SAFETY EVALUATION REPORT  
RELATED TO THE TOPICAL SAFETY ANALYSIS REPORT  
FOR THE NAC-C28 STORAGE/TRANSPORT CASK  
SUBMITTED BY NUCLEAR ASSURANCE CORPORATION

U.S. Nuclear Regulatory  
Commission

September 1988

FIGURE 1: CALCULATED SPENT FUEL CLAD  
MAX. TEMP. VS DECAY TIME (NAC-C28 S/T)

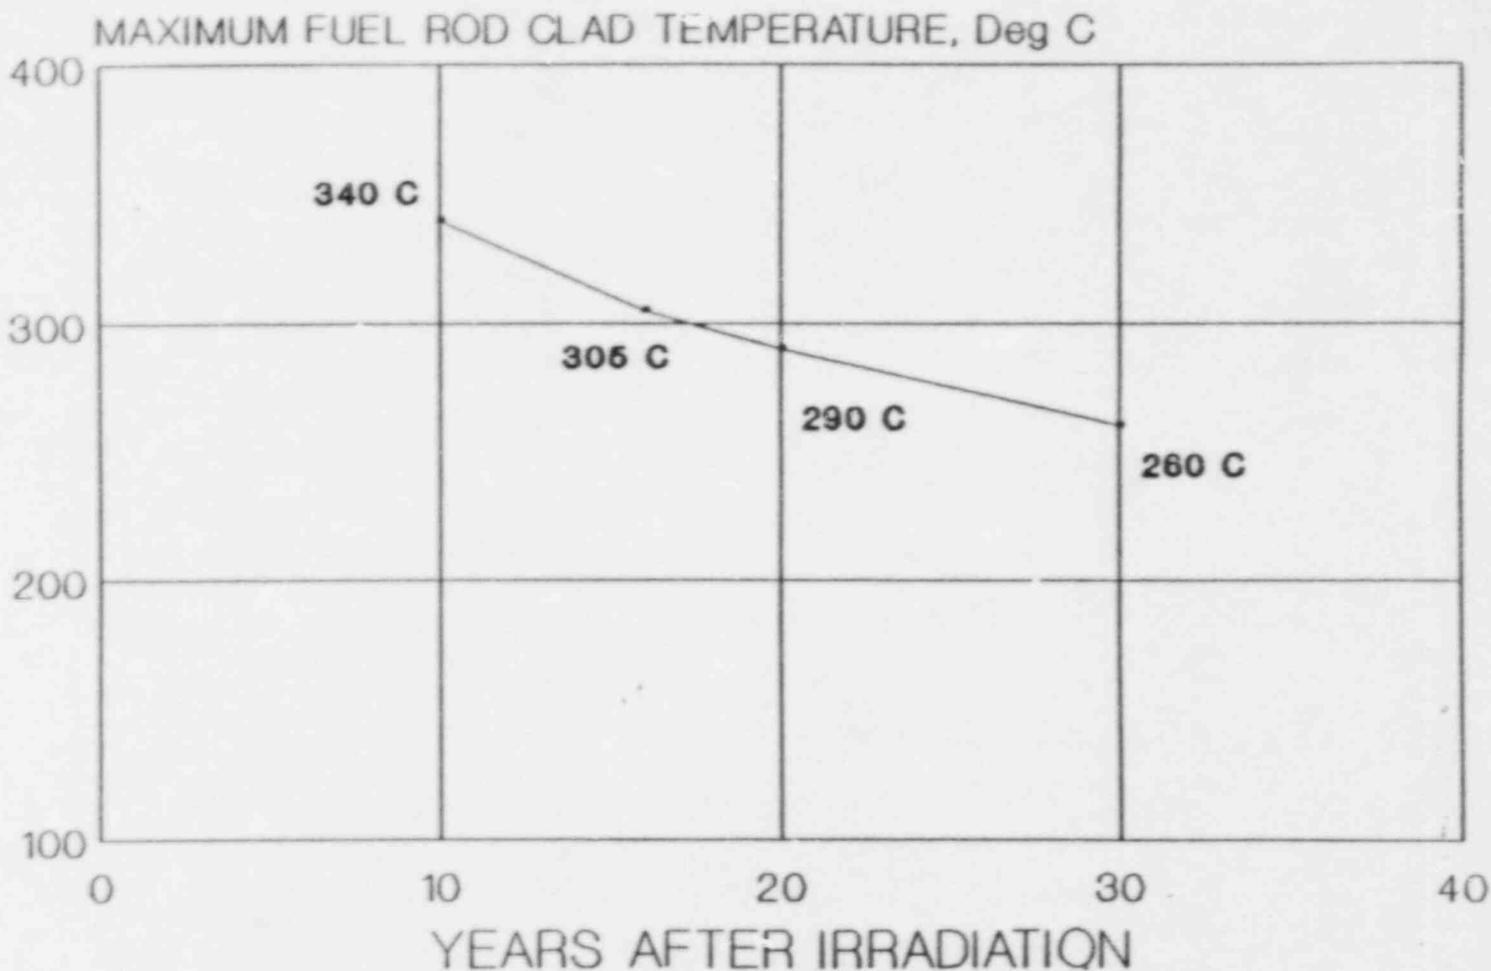
A confirmatory thermal analysis revealed that the maximum temperature for the fuel rods could be as high as 340°C (644°F) with a temperature decay curve as shown in Figure 1. Assuming a maximum room temperature fill gas pressure of 475 psig (490 psia) as specified on page 2A-321 of reference 9 and computing the pressure at the temperature limit of 340°C, the progress of damage based upon the DCCG analysis indicated the area of decohesion after 20 years of storage would be less than 10 percent. Consequently, an initial storage temperature not exceeding the design limit of 300°C (572°F) is acceptable for meeting the requirements of 10 CFR 72 Section 72.122(h).
